## Staff Report

**To:** Development Review Board  
**From:** Jennifer Marbl, City Planner  
**Date:** 02/15/2024  
**Subject:** 4 Church Street – Conceptual Site Plan Review for converting a duplex into a triplex  
**File:** SP# 1.2024

4 Church Street

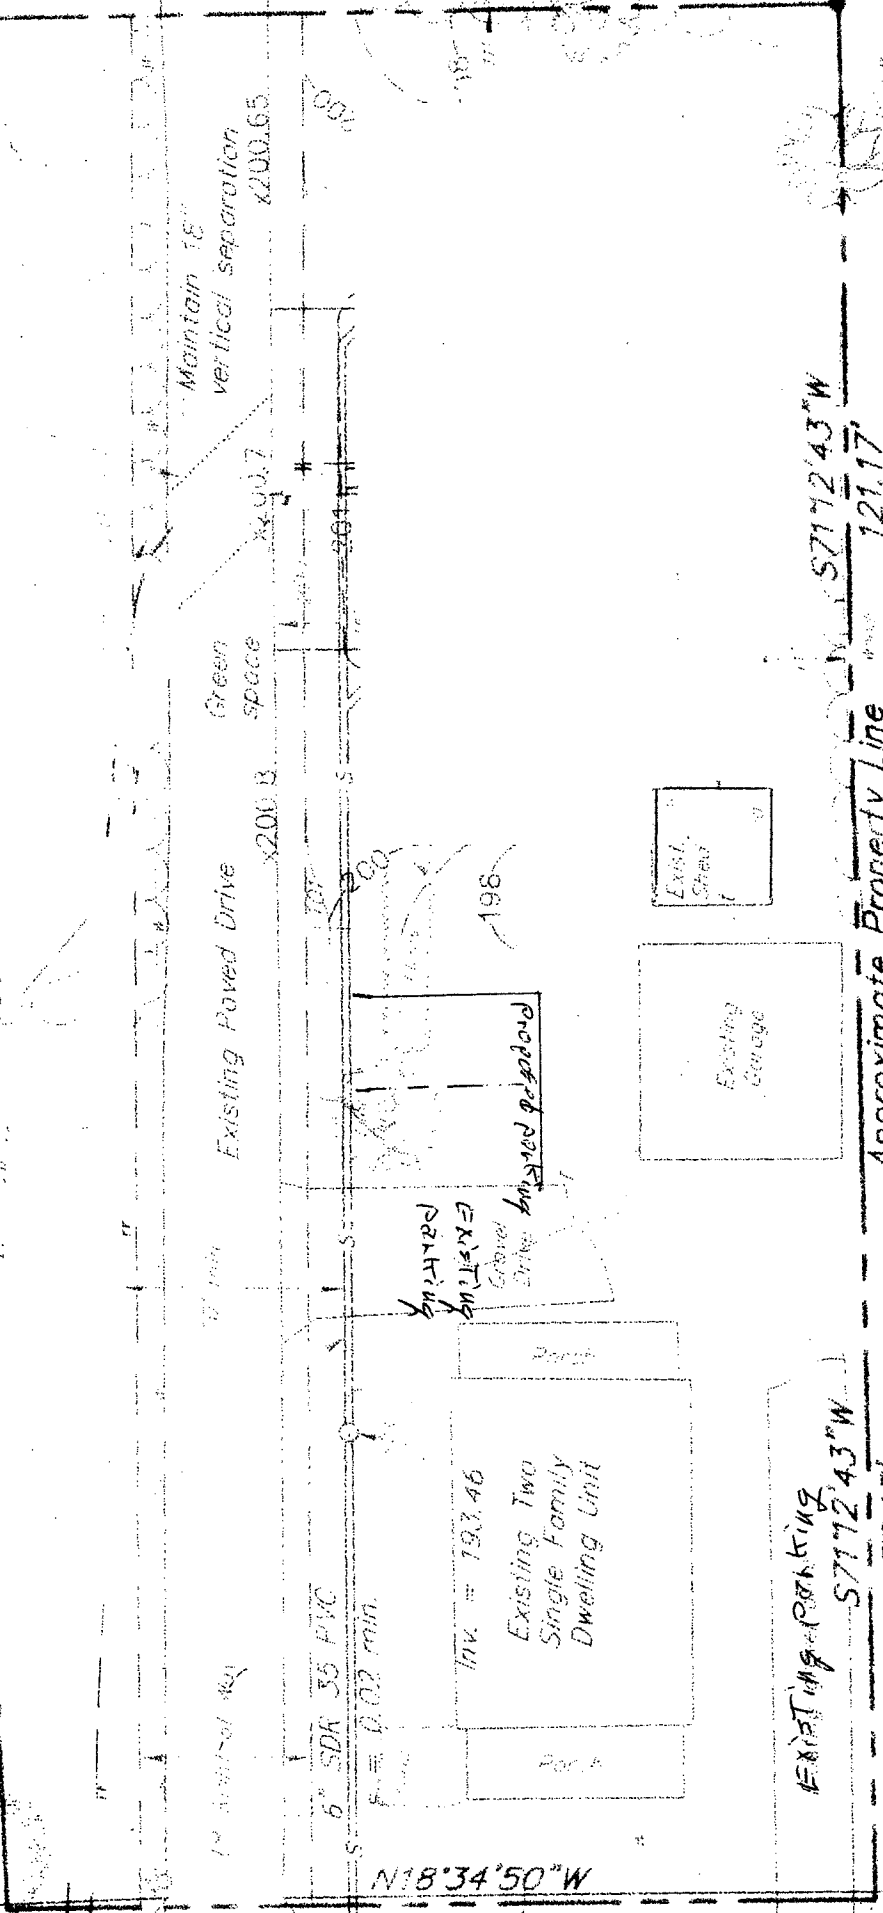
- C. Off-Street Parking Requirements
- A minimum of one parking space per residential unit is required. Existing parking spaces are not delineated, but there is sufficient space allotted for, at minimum, three vehicles.

**The applicant proposes to add two additional parking spaces, for a total of 5 spaces.**

The subject property currently has 2 curb cuts, one of which is also used as an access drive to the adjacent 55 Main Street commercial property. Although Section 705.B.1 now allows for only one curb cut per lot, the property's two curb cuts are pre-existing and not proposed to change.

2. All staff comments are addressed to the satisfaction of staff and the DRB.
3. The applicant shall request and obtain additional sewer capacity allocations for this project from the City prior to the issuance of a zoning permit.
4. The proposed parking area shall be hard-surfaced or gravel.
